Errata
CMOS VLSI Design
3rd Edition

Last updated 4 September 2006

Errata in 2nd Printing

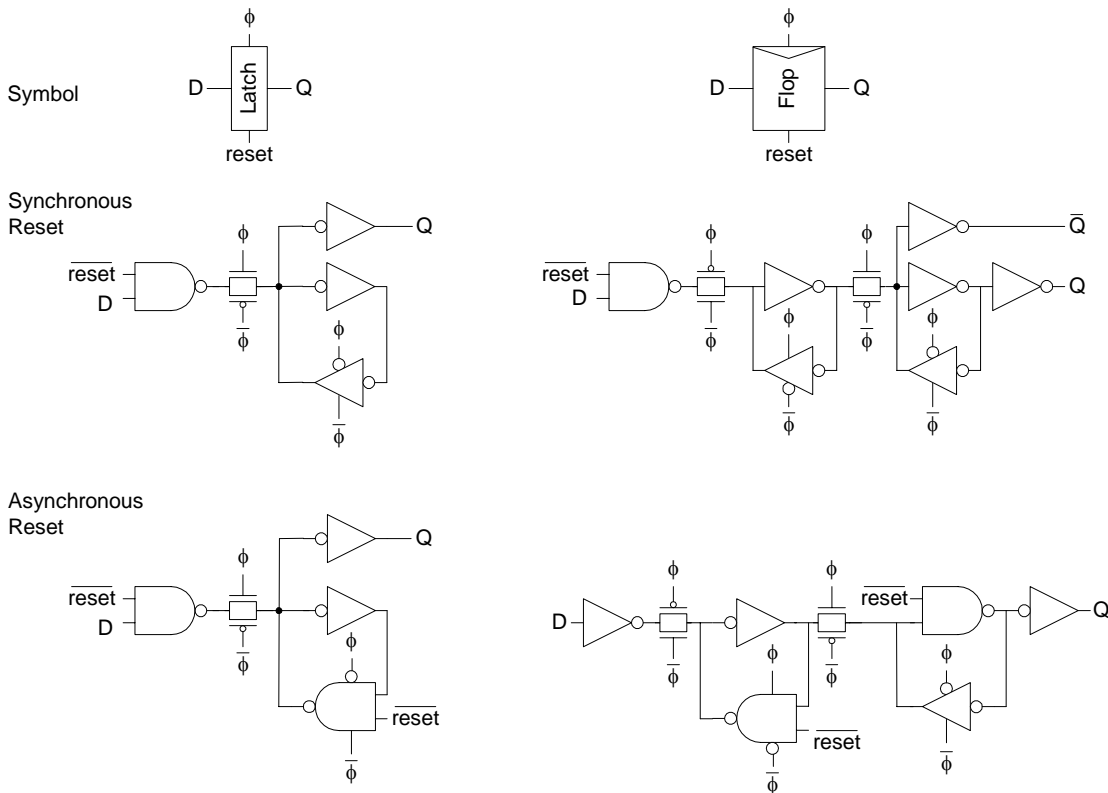
Page 409, Fig 7.24: Asynchronously Resettable flip-flop should be redrawn as (A. Rainier 3/9/05):

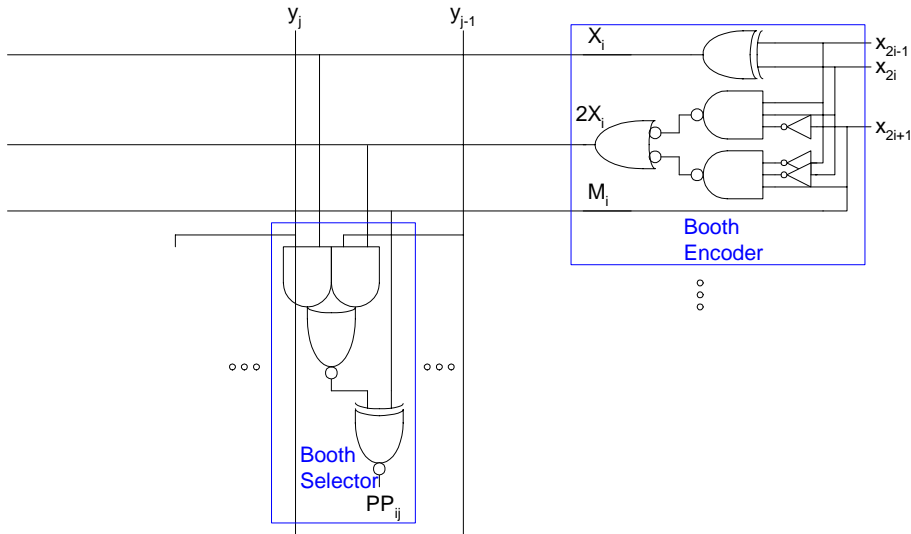
Page 699, Figure 10.75. Booth encoder is incorrect. Replace with:
